M1 Junction 15
Northampton Rail Freight Interchange

Stage 1 Road Safety Audit

Document Number:	NGW-BWB-GEN-XX-RP-TR-001_RSA1
BWB Reference:	NTH2315

Figure 2 – Location of problems identified within this audit;
A45 north of M1 J15

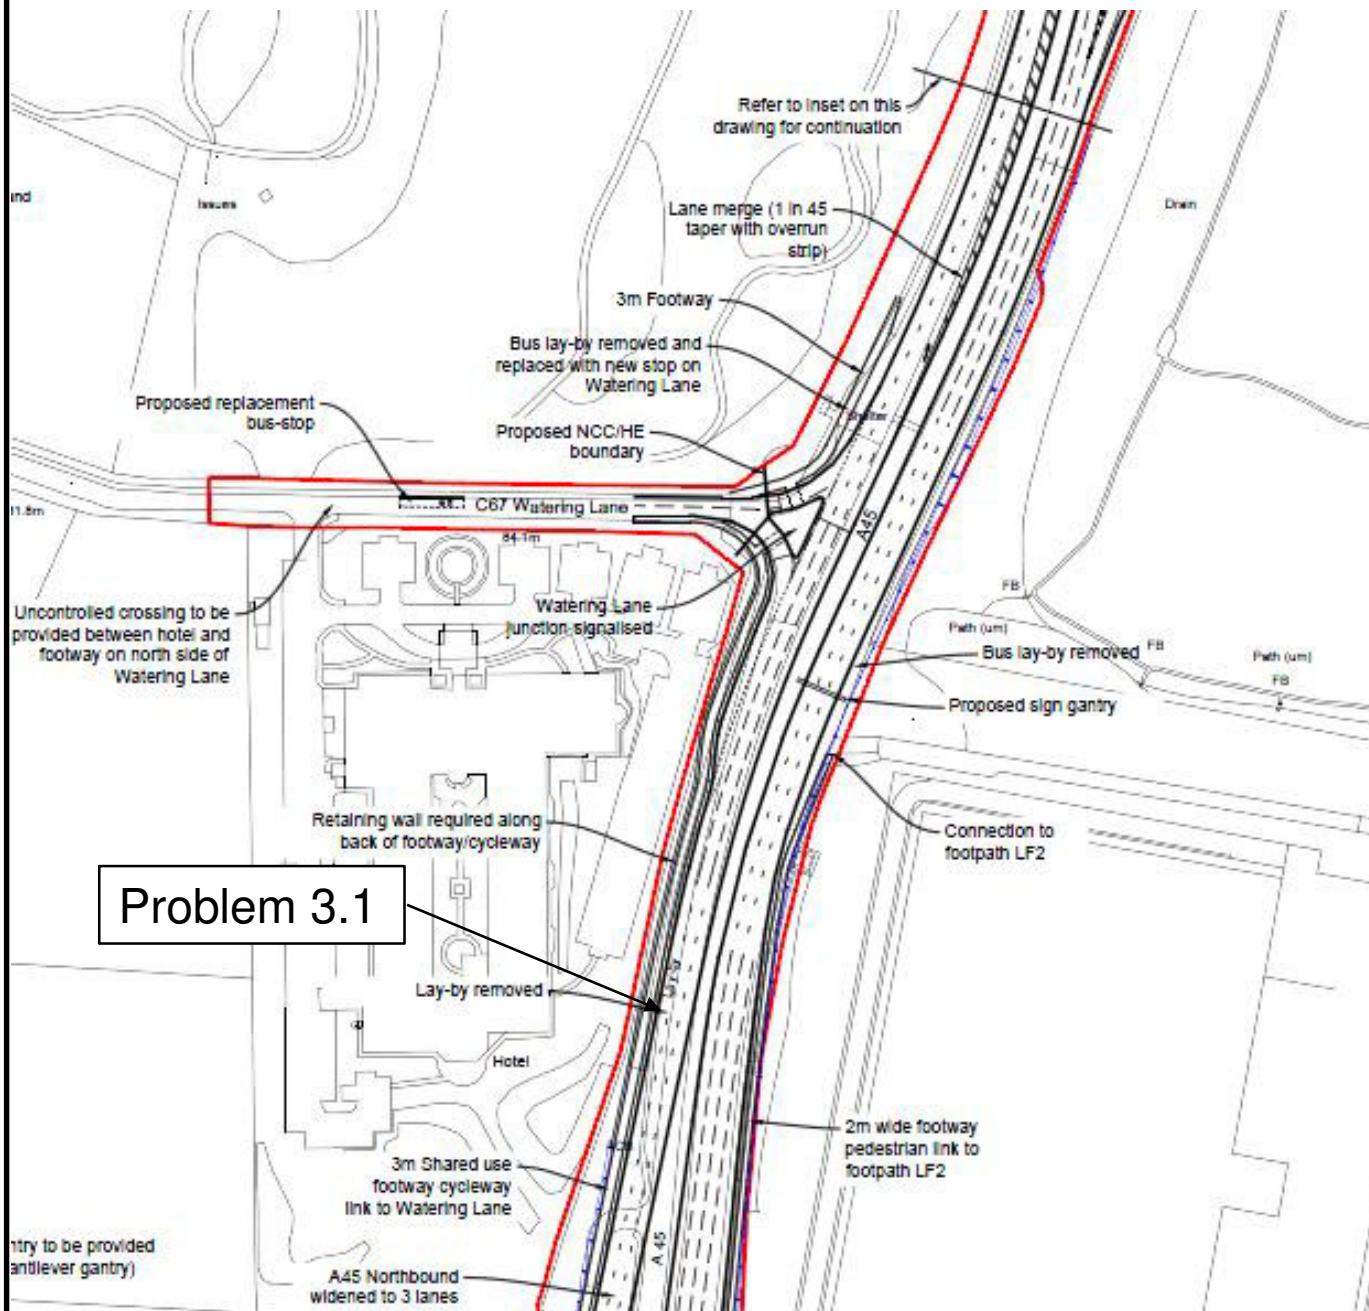
Summary: The lay-by is heavily used by HGVs, hence it is unknown what would happen to the displaced demand.

The lay-by, which is proposed to be removed, is heavily used by HGV drivers as witnessed during the site visit. There is no reference to the facility being replaced, hence it is unknown where displaced vehicles would attempt to park. HGV drivers could be tempted to park on Saxon Avenue on the exit from the roundabout and surrounding roads for example, which could create conflict with passing vehicles.

Further information is required with regards to the removal of the lay-by, to determine if any alternative solutions have been considered to prevent any inappropriate HGV parking.

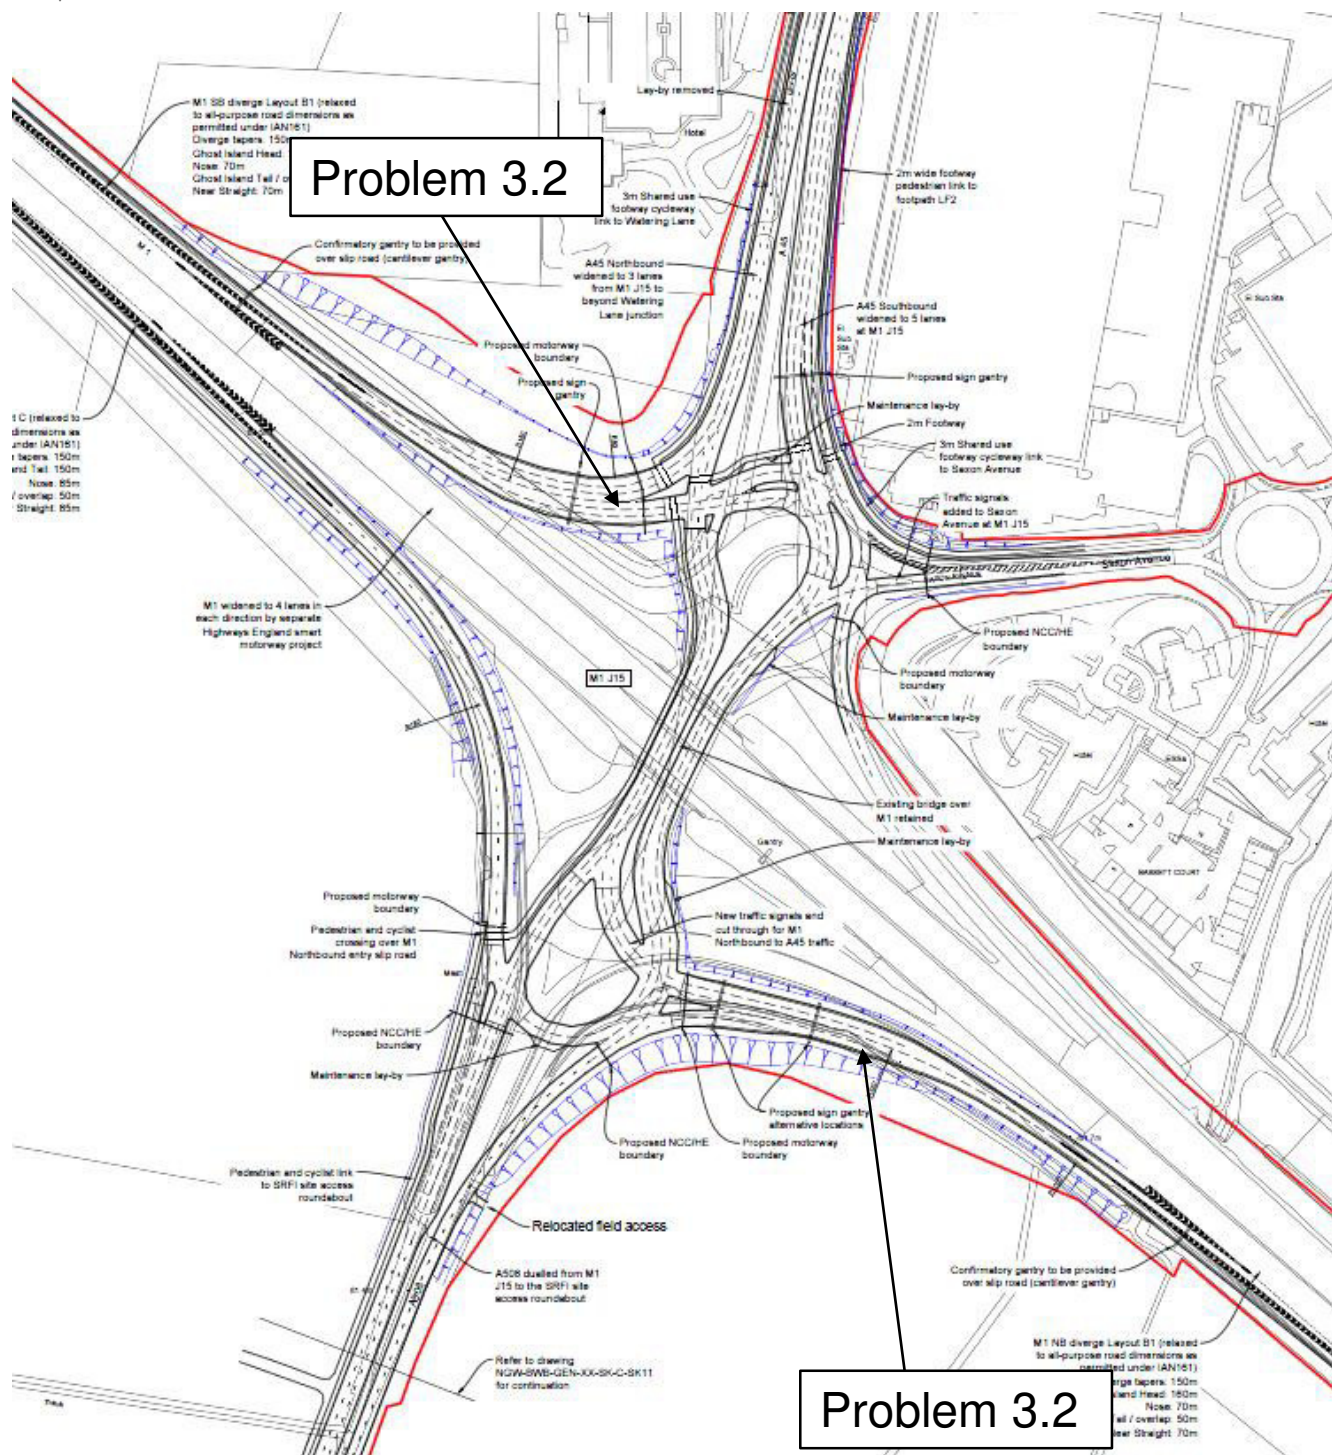
Summary: Potential weaving issues.

Early exiting drivers in the nearside lane of the southbound off-slip may want to travel south at Junction 15, towards the site. There is minimum weaving distance on the slip road for lane choice as drivers that were ready to leave the motorway early may not be able to get across to turn right at the junction, which could result in side swipe collisions. This issue is exacerbated by the fact that drivers using the later slip road lane are still able to travel north in the offside lane, which therefore results in vehicles crossing one another's path.

The same issue also arises at the northbound off-slip should drivers in the offside lane want to travel south at Junction 15, towards the site.

Ensure that suitable road markings and associated signage should be introduced to help drivers exit the M1 in the correct lane on the slip roads. It would also help if the two slip road lanes were allocated one direction of travel, for instance on the southbound off-slip the first slip road would provide access to the A45 and the second slip road provide access to Saxon Avenue and the A508. This would result in motorists only having to switch one lane if they found themselves on the wrong slip road.

Road markings and associated signage at the junction will have to be thoroughly examined in further detail as part of the Stage 2 RSA regardless, to ensure that the considerable changes to the junction are as clear as possible to drivers.

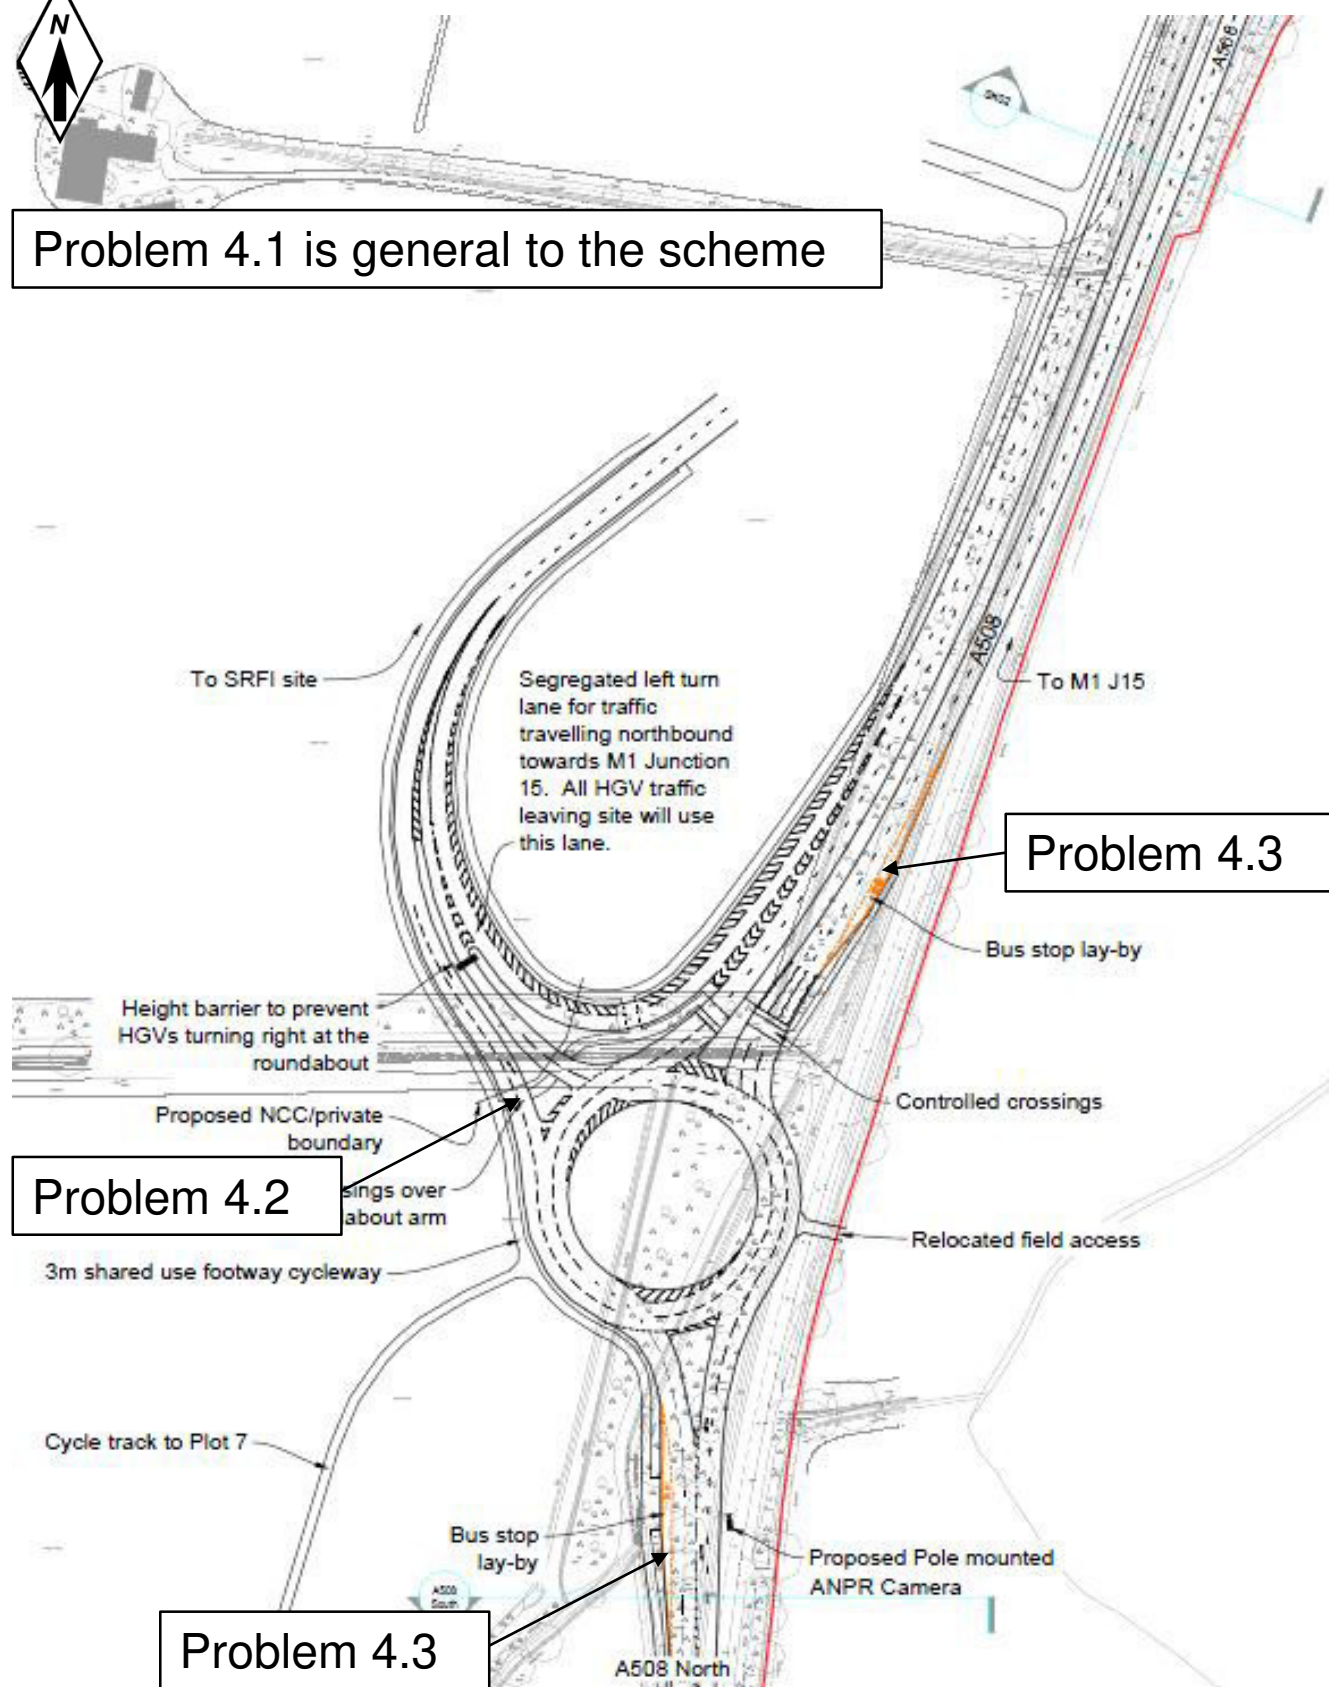
The road markings as currently proposed are not clear. For example, on the site access the centreline is not central. In addition, directional road markings as well as arrows will be required at the roundabout to make it clear as to what movement is permitted in each of the entry lanes. As a result, this could result in vehicles not taking the correct line of travel if they were guided by the road markings as currently proposed.

The crossing facility provided over the site access arm is proposed as an uncontrolled crossing. However, the access will potentially be busy during peak times, and the exit from the roundabout is provided with two lanes merging to one within the site. This could make it difficult for pedestrians to cross the carriageway and predict vehicle movements exiting the roundabout. This is exacerbated by the provision of two lanes allowing access to the site around the roundabout.

The proposals include bus stops provided on both the northbound and the southbound A508 approaches to the roundabout. The northbound bus stop in particular is provided close to the roundabout and is also provided in addition to a flare from one lane to

two lanes. This results in a potentially confusing layout, as a bus pulling into the bus stop, could be followed by a car, expecting it to turn into the site, for it to suddenly stop. This could potentially lead to shunt type collisions.

Problem 4.1 is general to the scheme

Problem 4.2

Problem 4.3

Ensure that the road markings and signage strategy at the site access junction is completely clear for all users.

Assuming pedestrian movements across the site access arm would be low, it could be beneficial to provide a signal controlled facility on the basis that it should not prejudice the capacity of said junction.

The bus stops should be located at a suitable distance away from the roundabout to prevent any confusion for motorists at the roundabout.

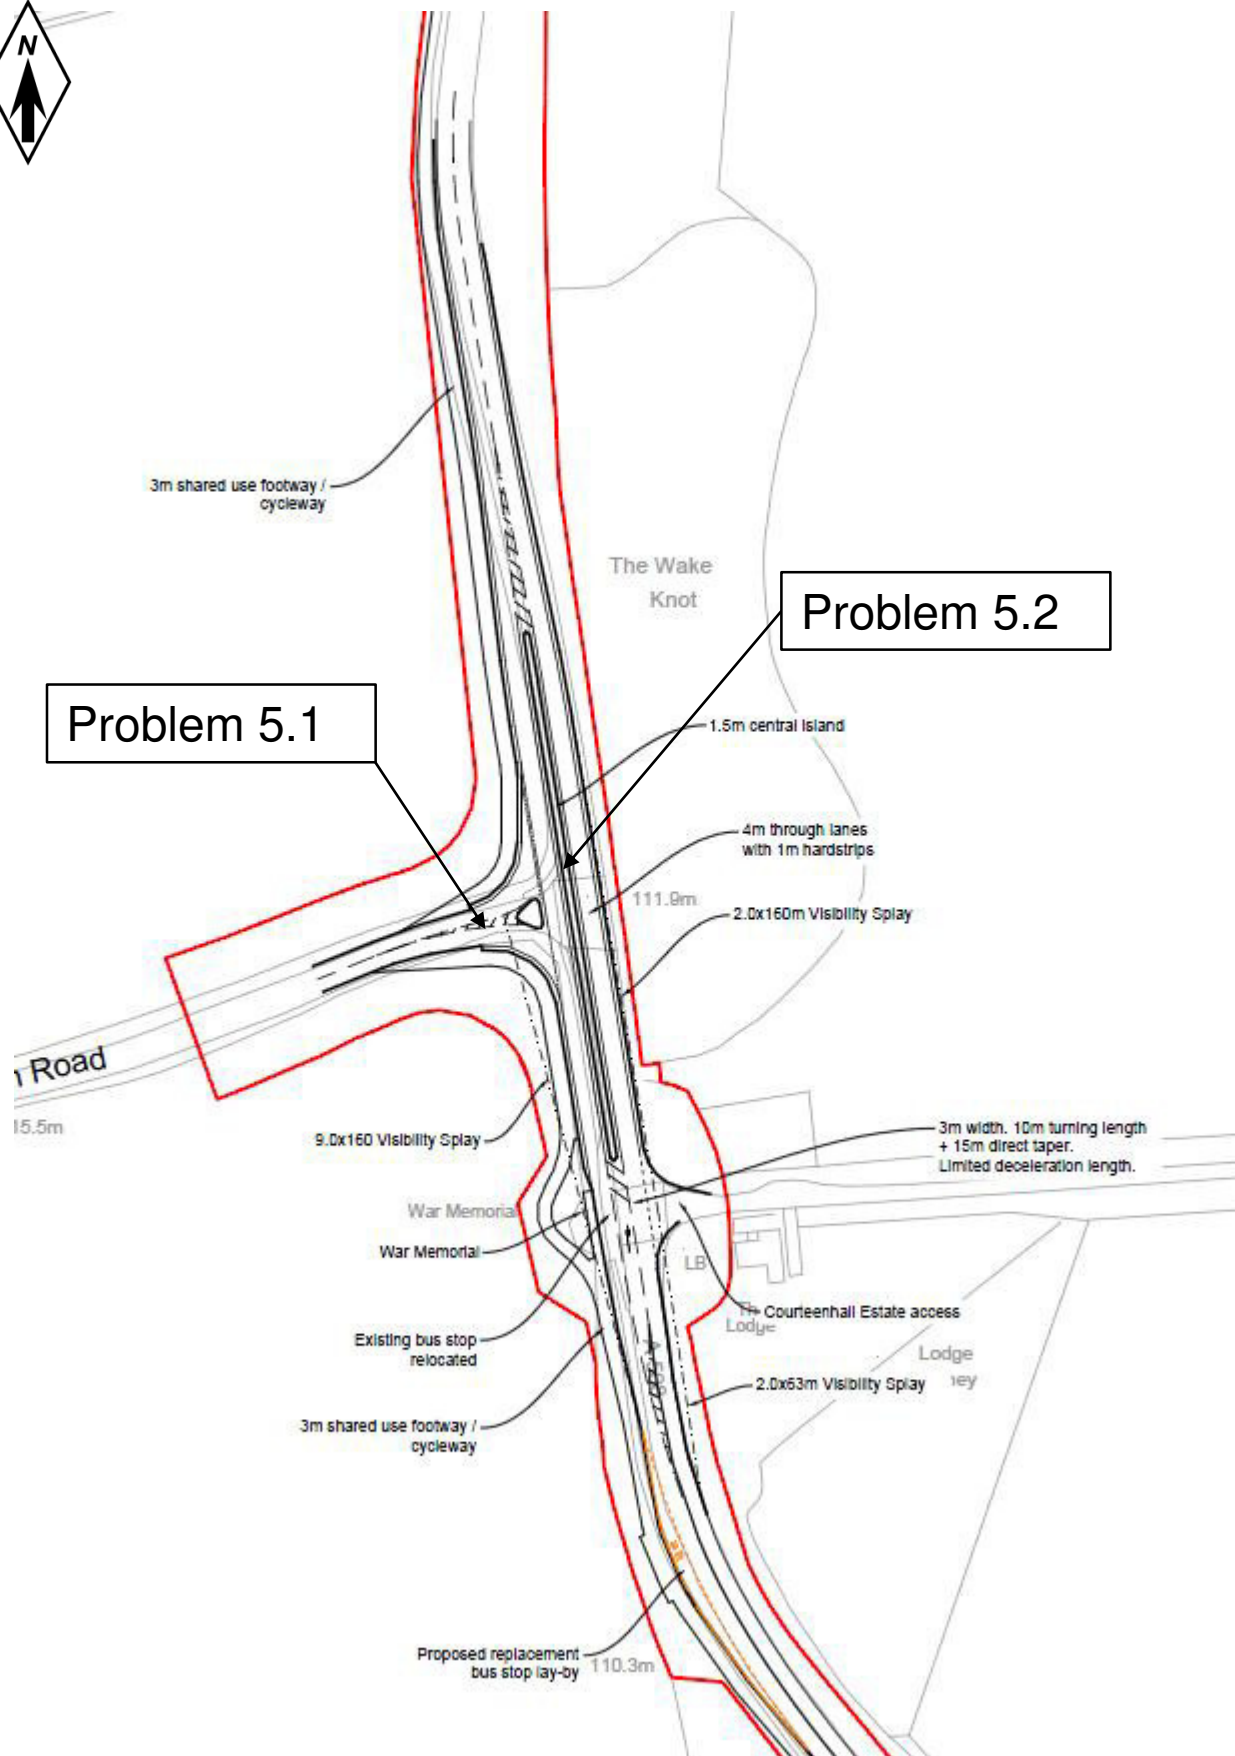
Summary: It is unclear how pedestrians and cyclists would cross Courteenhall Road.

A shared surface pedestrian/cycle route routes along the western side of the A508. A refuge is proposed in the centre of Courteenhall Road to enforce the left-in/left-out arrangement. However, it is unclear at this stage how pedestrians and cyclists would cross Courteenhall Road, because it does not appear that they would be able to make use of the refuge. This could result in such users being put in conflict with vehicles travelling along Courteenhall Road.

Summary: Central island could cause conflict.

The junction of the A508/Courteenhall Road is proposed to be revised to a left-in/left-out junction which is forced by the introduction of a narrow central kerbed central island. If the central island was not provided with bollards or signage, it could be inconspicuous to drivers resulting in them colliding with it.

It is recommended that pedestrians and cyclists are provided with the opportunity to use the refuge to break their crossing of Courteenhall Road.

Whilst more of a detailed design issue, it should be ensured that suitable signage, and bollards are provided to make the central island as visible as possible.
